Addendum to User's Manual 250-0225

Document no. 250-0225a

Figure 8. DISABLE/ENABLE Terminals

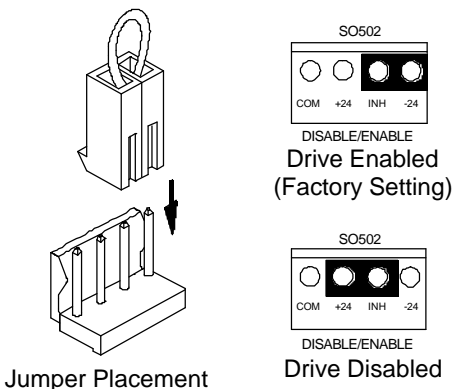
Due to an error which was not caught until after the print run was completed, Figure 8 in the manual is illegible. The correct illustration is shown below.
